— Bport/Accelerations Task Group

Agenda

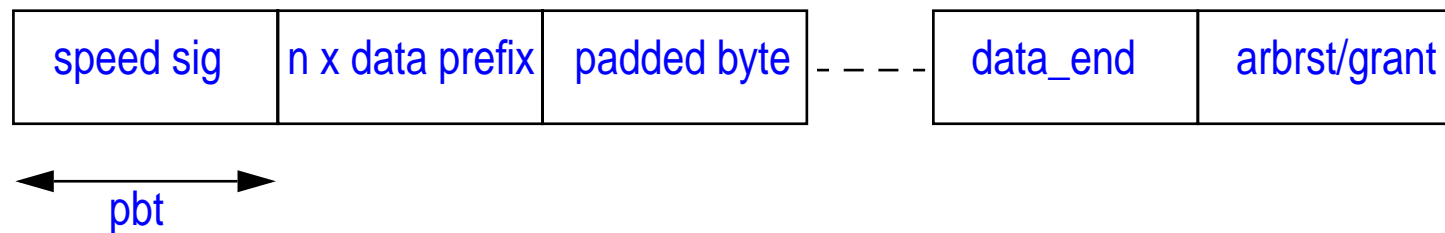
- Current packet ending is:

[n DATA_END | n DATA_END_ERR]

where n is equal to the ratio of the port operating speed and the packet speed.

Should include ARBRST, ARBRST_GRANT or GRANT symbol i.e.

- Note, if no ARBRST or GRANT, second pattern of DATA_END is sent. Guarantees there are always two control characters at end of any packet even when n=1.

[n DATA_END | n DATA_END_ERR]..
..[n arbrst | n ARBRST_GRANT | n GRANT | n DATA_END]
